From: Tasya Gray <ngray@dofnw.com>
Sent: Thursday, April 22, 2021 8:03 AM
To: Knittel, Janette
Subject: Former Rhone Poulenc Redline
Attachments: 2021-04-21 DRAFT FINAL Former Rhone Poulenc Pre-CMS Data Collection Work Plan.docx; EPA Comments_FRP Draft Pre-CMS WP QAPP_2021-04-21.xlsx; 2021-04-21 DRAFT FINAL FRP Revised QAPP.docx

Draft Pre-CMS Data Collection Work Plan

FORMER RHONE POULENC SITE

**EPA Comments for the
Draft Pre-CMS Data Collection Work Plan dated April 5, 2021
Former Rhone Poulenc Facility, WAD 00928 2302**

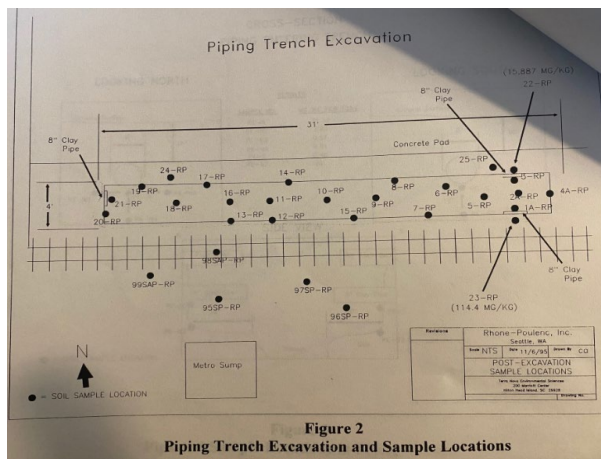
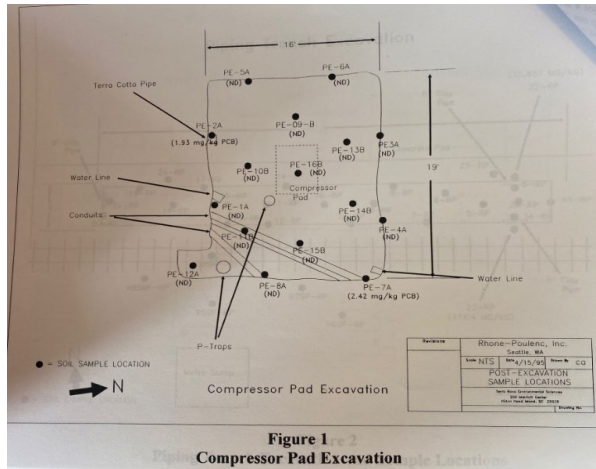
Comment Number	Page(s)	Section	Location	Comment	Response
25		Figures 3 and 4		<p>EPA appreciates the addition of the figures showing historic structures with the monitoring wells and other features.</p> <p>In Figure 4, the difference between the purple and pink shading is unclear. Add both to the legend.</p> <p>Per the 1998 Interim Measures Report, the location of the PCB excavation was near the south side of the autoclave building (#14 on historical maps, Figures 3 and 4) not the compressor pad (#18/19 on historical maps, Figures 3 and 4). Adjust the figure accordingly.</p>	<p>The two colors were initially used in Figure 4 because two areas overlapped. Shading has been modified and added to the legend per the comment. With regards to the location of the PCB excavation - we reviewed the 1998 report and also a 2004 Geomatrix report that pulled various historical maps together. See attached summary and historical maps.</p>

The April 8, 1998 Interim Measures Report prepared for Rhodia Figure 1 shows the Compressor Pad Excavation and the locations of samples PE-2A and PE-7A with PCB concentrations of 1.93 mg/kg and 2.42 mg/kg, respectively. Those sample locations PE-2A & PE-7A are also shown on Figure 2-4 (Soil Sample Location Map) of the November 2004 Geomatrix Draft Corrective Measures Study Uplands in relation to historical buildings. The location of this excavation is shown to be on the northwest corner of location 19 on Figures 3 & 4 of the Draft Pre-CMS Data Collection Work Plan, historically referred to as the Compressor Shed.

The 1998 Rhodia report also provides locations of samples related to the piping trench excavation (Figures 2 & 3). Figure 3 specifically shows residual PCB location PE-N with a PCB concentration of 31.12 mg/kg on the northern sidewall below the 8" clay pipe. This excavation area is shown on Figure 2-4 of the 2004 Geomatrix document mentioned above. The excavation is shown to be located on the southeast corner of building 15, historically known as the Oil Storage Area, which is connected to the Autoclave Building (Location 14 on Figures 3 & 4 of the Pre-CMS Data Collection Work Plan).
